PEREZ RESIDENCE — PEREZ RANCH

Steel-frame / wood-wall hybrid residence · 43 Percy Howard Rd, Huntsville, Walker County, Texas

Preliminary design set for PE review and permit routing · 10/05/2026

A-501

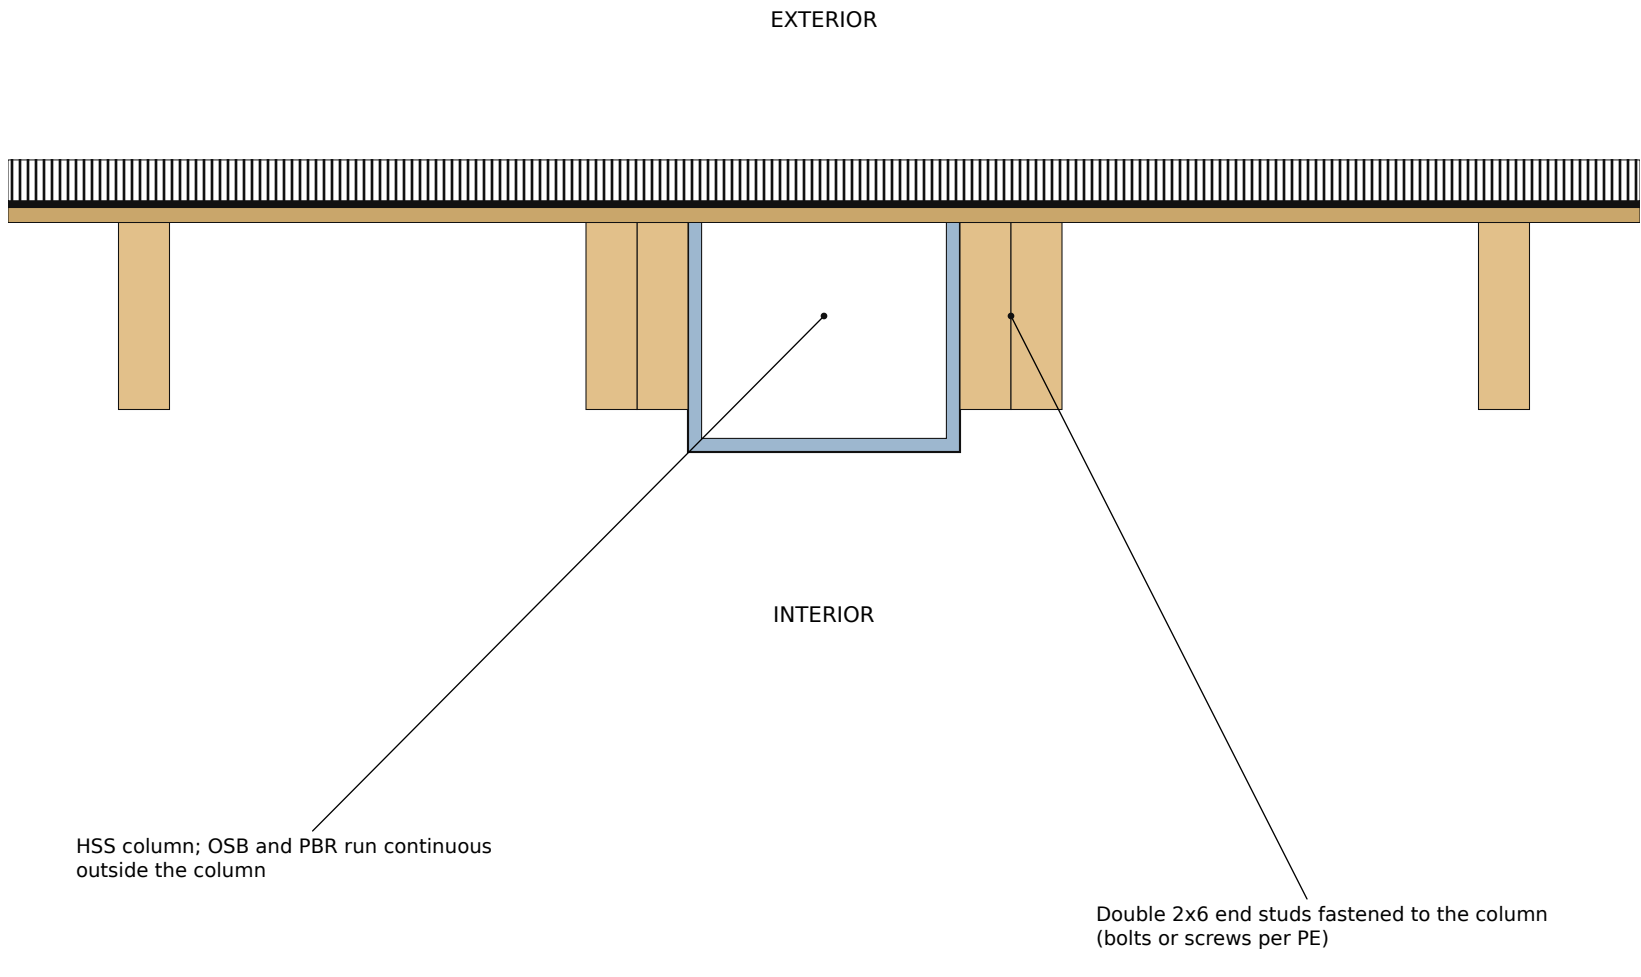
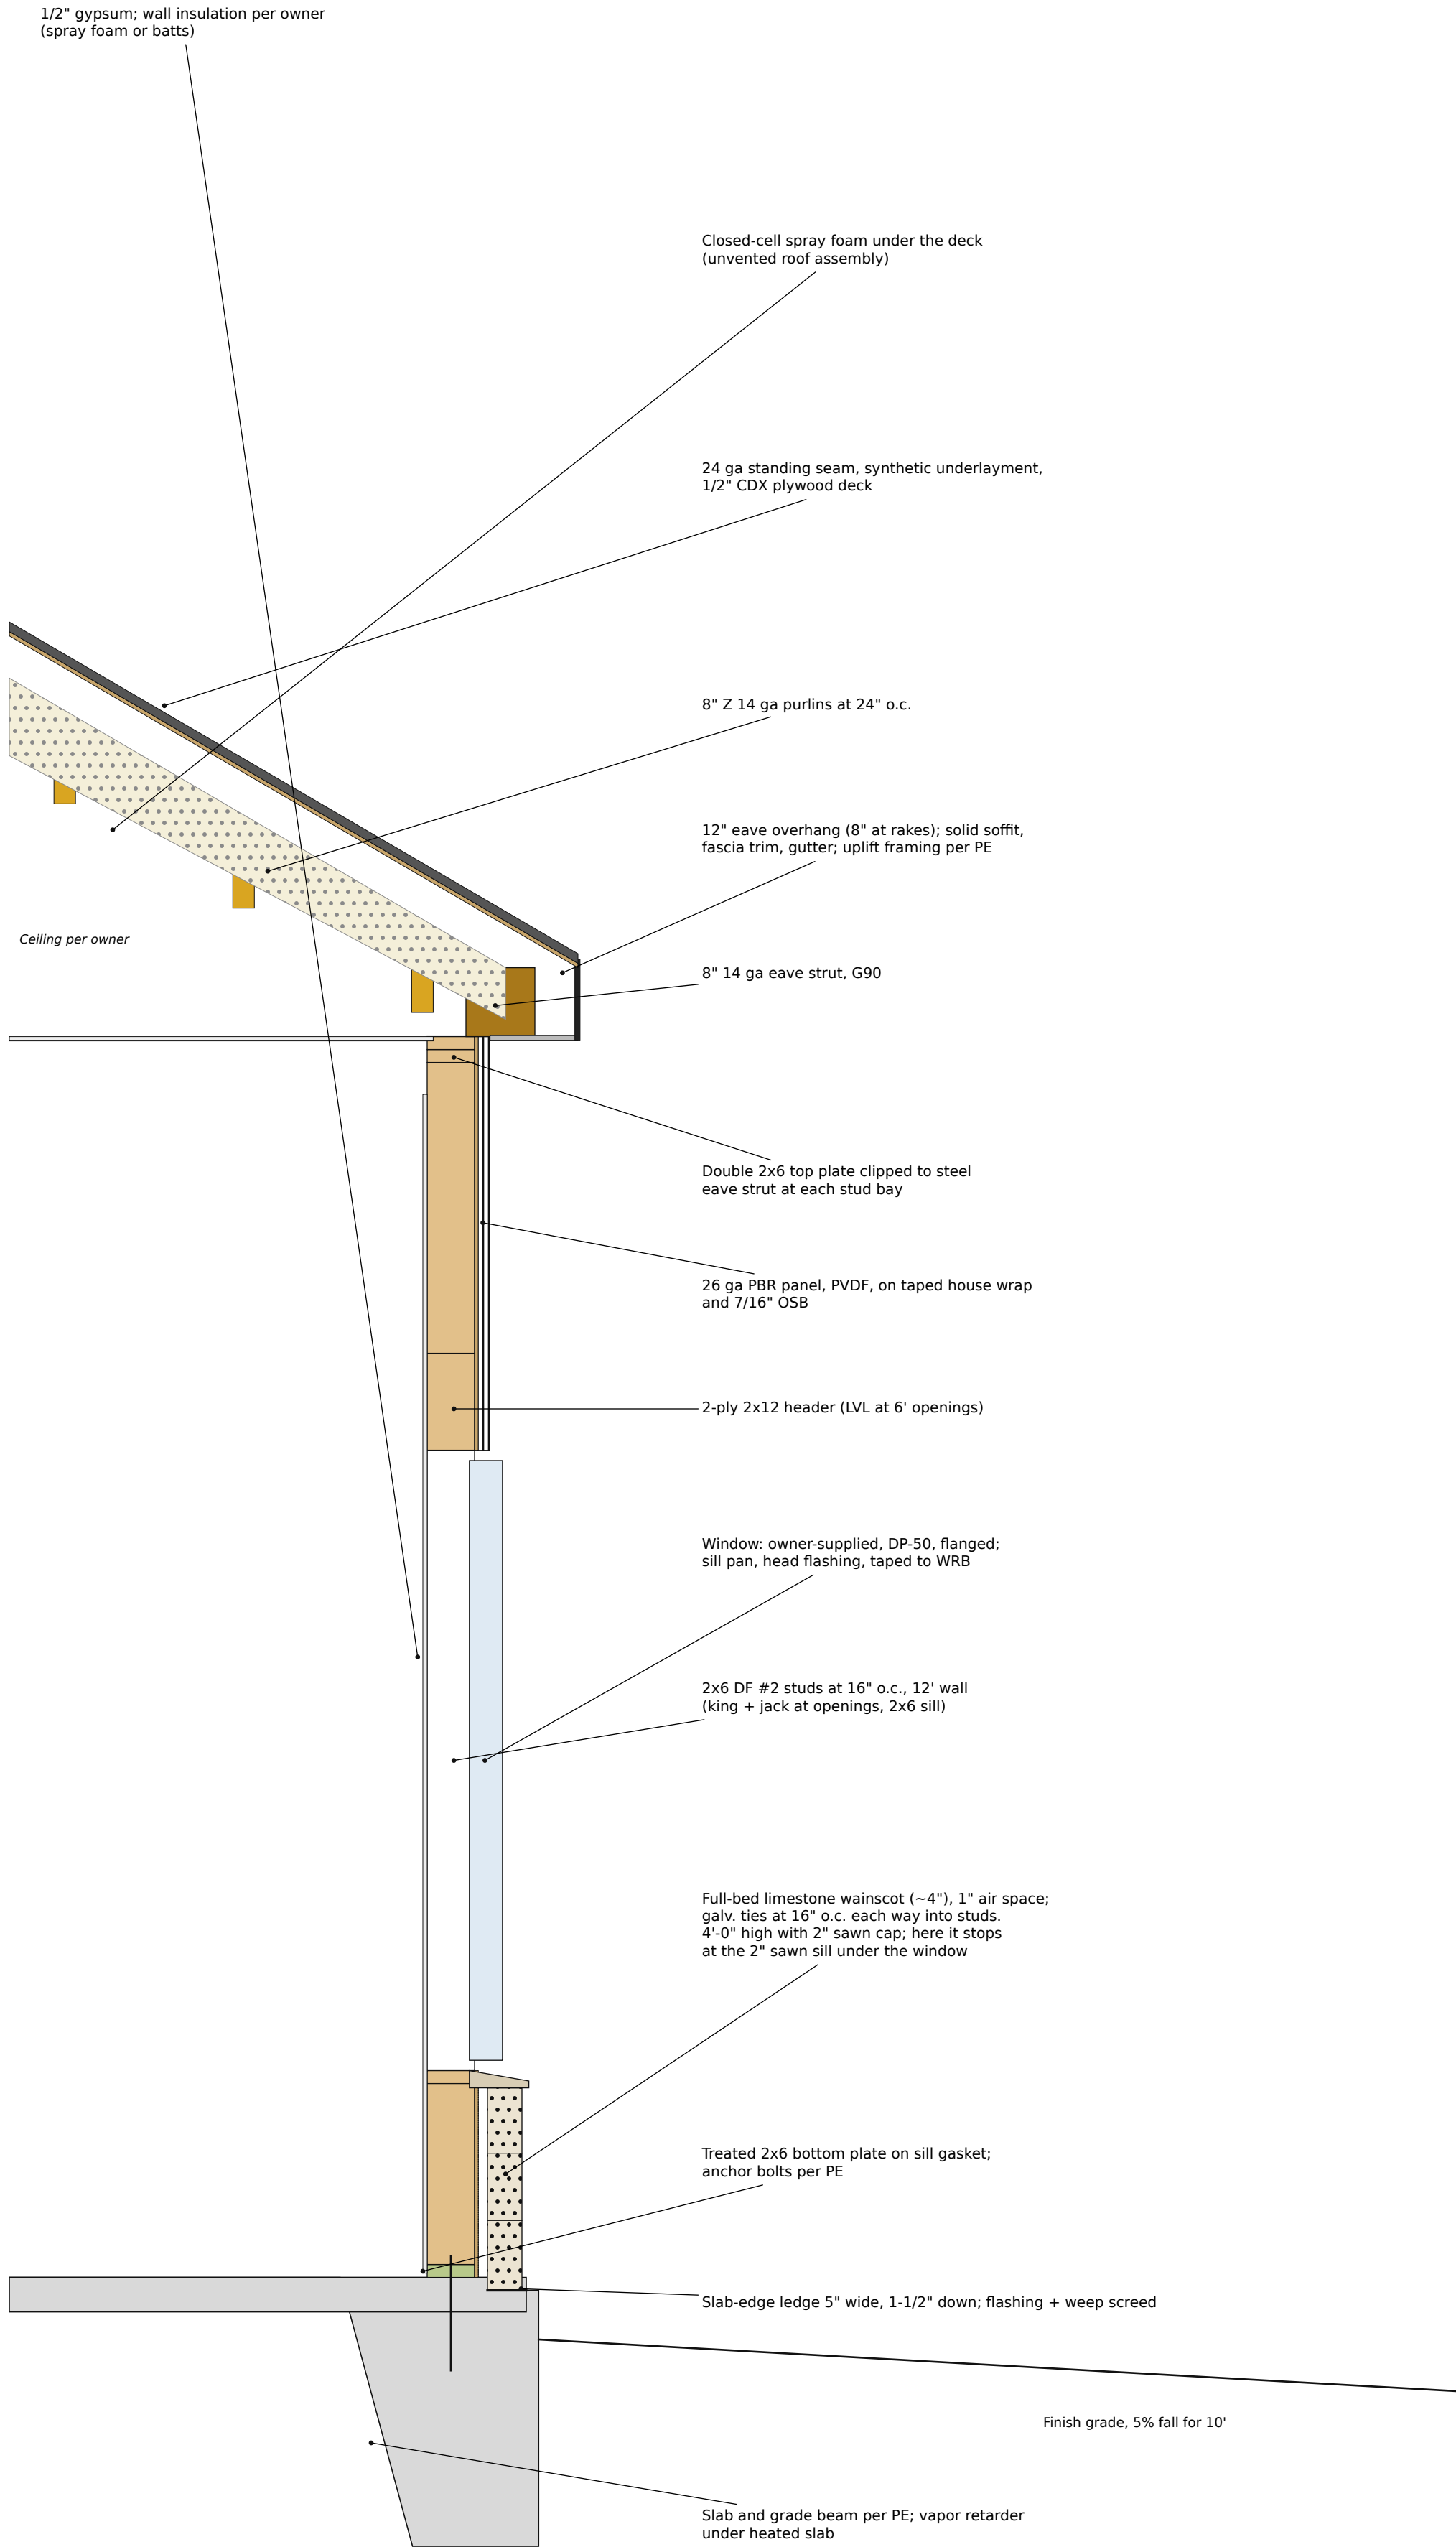
OWNER COORDINATION MARKUP - 10/07/2026
Omit 4-ft limestone wainscot at the carport/master bath wall, carport/suite wall, master-closet/foreneway wall, and kitchen/foreneway wall. Continue metal cladding to slab; retain framing. Concrete slab-edge ledge/reinforcement remains subject to PE review. BOM: wainscot 864 SF, wall panels 4,542 9 SF. NOT FOR CONSTRUCTION.
